P-10017

JINDAL ALUMINIUM LTD.
BANGALORE-560073 (INDIA)

PARTY'S NAME SMEW TEXTILE MACHINERY PVT. LTD.,
GANDHI NAGAR

DESCRIPTION ROUND TUBE

S2533

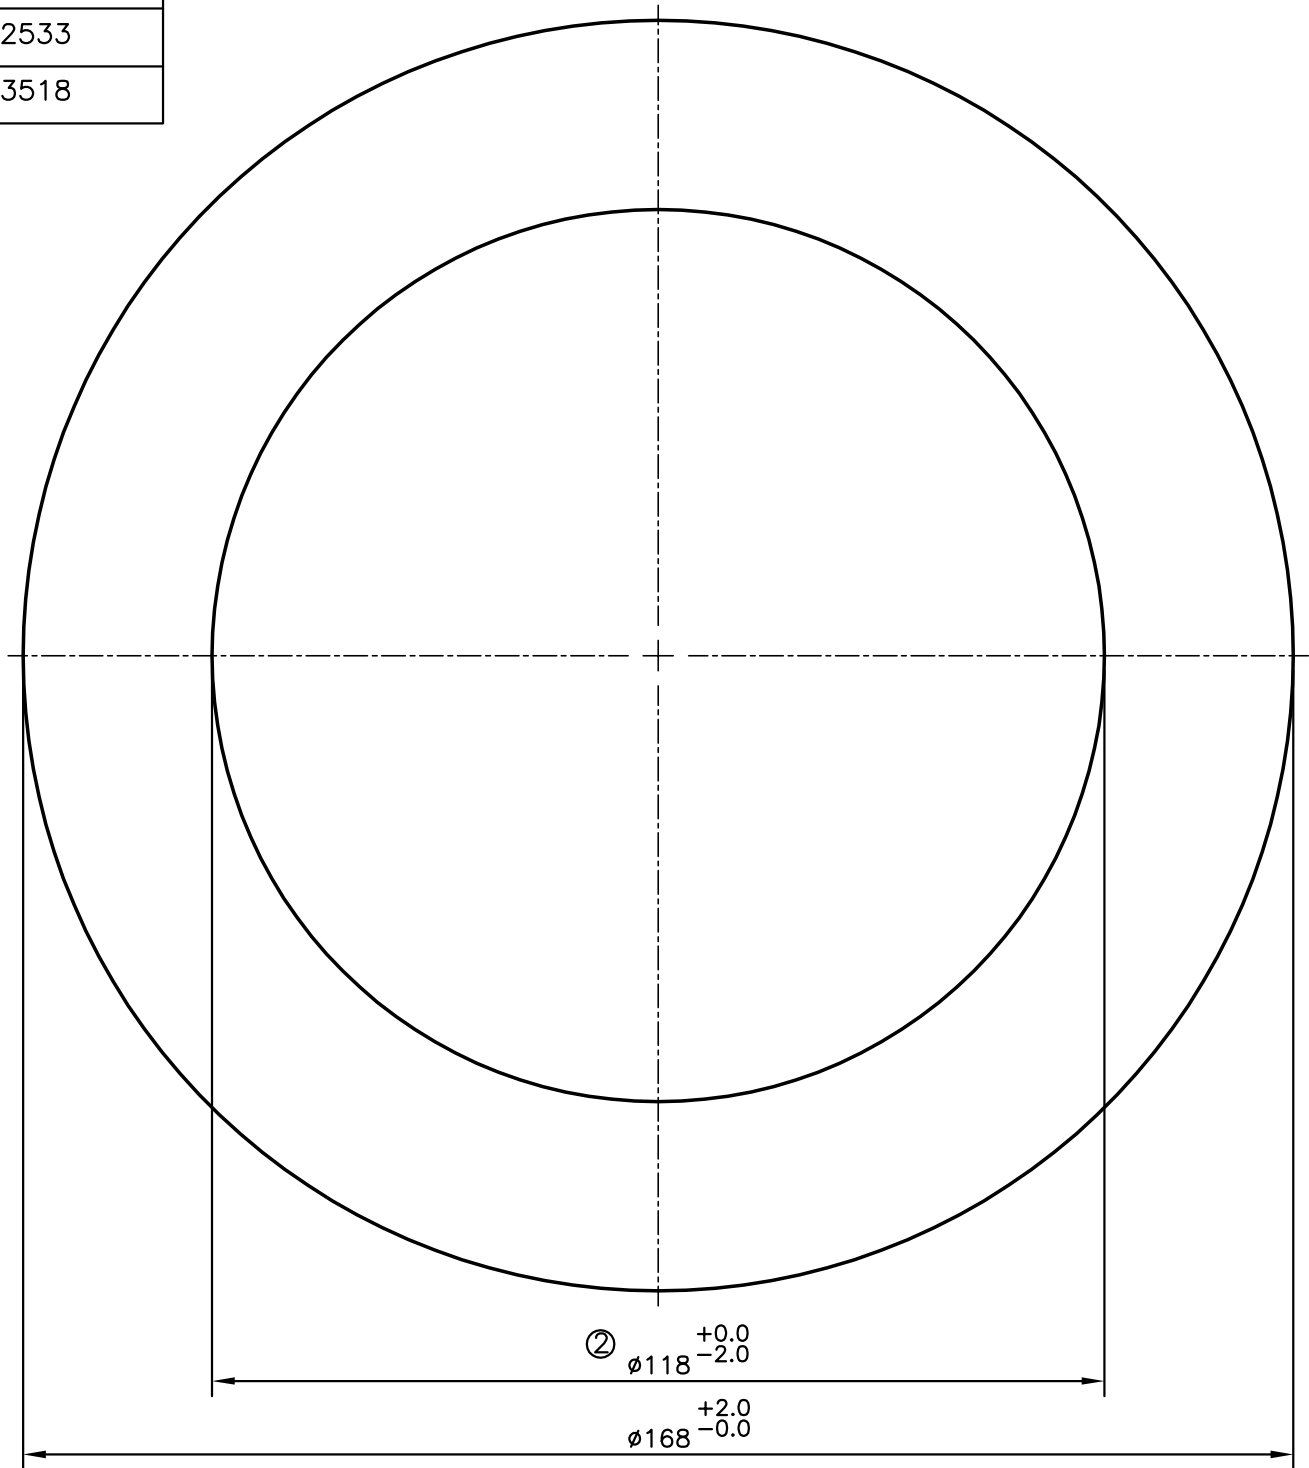
OVALITY ± 2.5 mm ISSUE-2:- DIMENSION CHANGED FROM $\phi 116$ TO $\phi 118$ mm
WEIGHT ALSO CHANGED FROM 31.317 kg/M TO 30.324 kg/M
